Item Name: Crosstube Turning Detail

DART AEROSPACE LTD		Work Order:	88786
Description: Crosstube Assembly (412 High Aft)		Part Number:	D412-664-243
Inspection Dwg: D412-664-243 Rev: E		Page 1 of 2

DRAWING NO. D412-664-243	TITLE CROSSTUBE ASSEMBLY (412 HI AFT)	REV. E	DART AEROSPACE LTD ENGINEERING ORDER		D.E.O. NO. D412-664-243-E-1	SHEET NO. SHEET 1 OF 2	SCALE NTS
DRAWN	CHECKED	MFG. APPR.	APPROVED	DE APPR.			
DATE 11.03.31	DATE 11/03.31	DATE 11.03.31	DATE 11/03.31	DATE 11.03.31

DRAWING NO. D412-664-243	TITLE CROSSTUBE ASS'Y (412 HI AFT)	REV. E	DART AEROSPACE LTD ENGINEERING ORDER		D.E.O. NO. D412-664-243-E-2	SHEET NO. SHEET 1 OF 1	SCALE NTS
DRAWN <i>MP</i>	CHECKED <i>ASS</i>	MFG. APPR. <i>EE</i>	APPROVED <i>MP</i>		DE APPR. <i>MP</i>		
DATE 11.09.07	DATE 11.09.19	DATE 11.09.19	DATE 11.09.19		DATE 11.09.19

D212-664-243
ASSEMBLY DETAIL

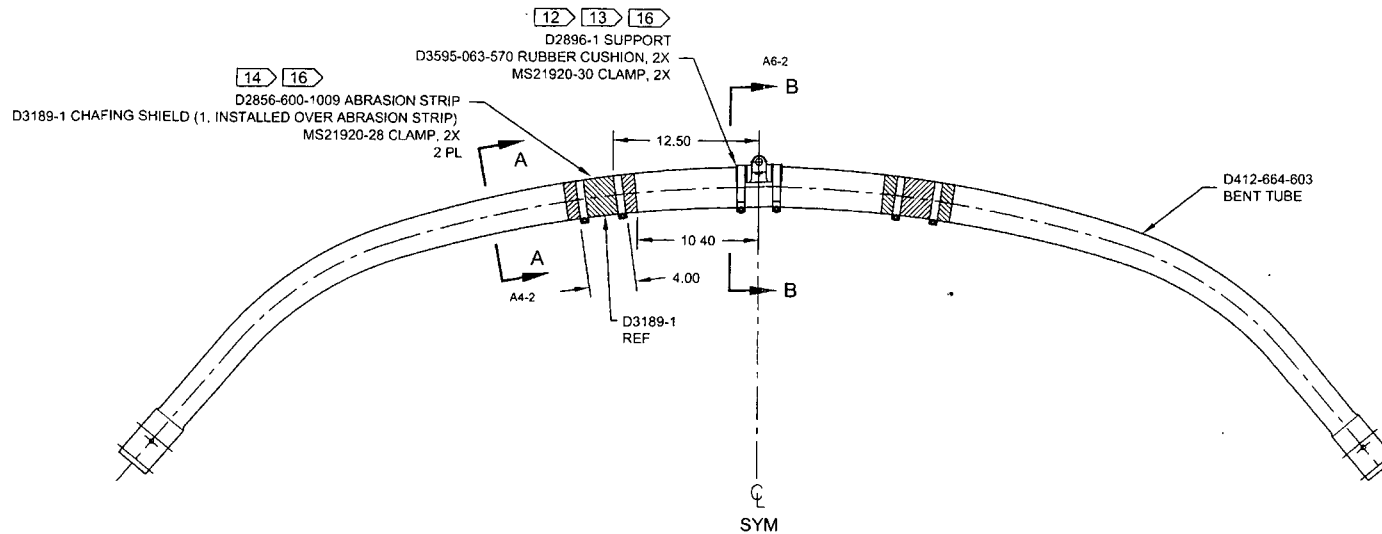
PURPOSE:

REMOVED ABRASION STRIP IN FAVOR OF A THIN LAYER OF PROSEAL 890.

NOTES 2 AND 14, SHEET 1 ARE AMENDED AS FOLLOWS:

- 2) FINISH: CHEMICAL CONVERSION COAT PER DART QSI 005 4.1
PRIME INSIDE AND OUTSIDE PER DART QSI 005 4.2
MASK UNDERSIDE OF CROSSTUBE AS SHOWN (HATCHED AREA)
PAINT OUTSIDE PER DART QSI 005 4.2
AFTER PAINTING, APPLY CLEAR COAT ON HATCHED AREA
- 14) APPLY A THIN COAT OF PROSEAL 890 ON INSIDE CONCAVE SURFACE OF D3189-1
CHAFING SHIELD AND LET CURE PER MANUFACTURER'S INSTRUCTIONS. INSTALL
PROSEALED D3189-1 CHAFING SHIELD ONTO CROSSTUBE BY APPLYING A THIN COAT OF
PROSEAL 890 ONTO CROSSTUBE. BE SURE TO ELIMINATE ANY AIR GAPS.

IS:

D3189-1 CHAFING SHIELD (1, INSTALLED OVER PROSEAL 890)
MS21920-28 CLAMP, 2X
2 PL

WAS:

D2856-600-1009 ABRASION STRIP
D3189-1 CHAFING SHIELD (1, INSTALLED OVER ABRASION STRIP)
MS21920-28 CLAMP, 2X
2 PL

MASK AREA PRIOR TO PAINTING AND
APPLY CLEAR COAT AFTER PAINTING
